PLANNING AND CHANGES

Issues in PB_A_1.1.1, changes require in PB_A_1.2-

Changes in PB_1.3.2-

PB_A_1.3.2

LED

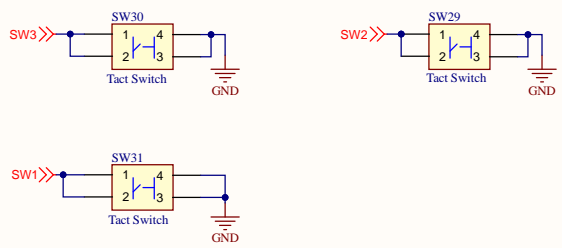
RGB LED added for -
1. Wrong Time
2. ALert
3. Low Battery
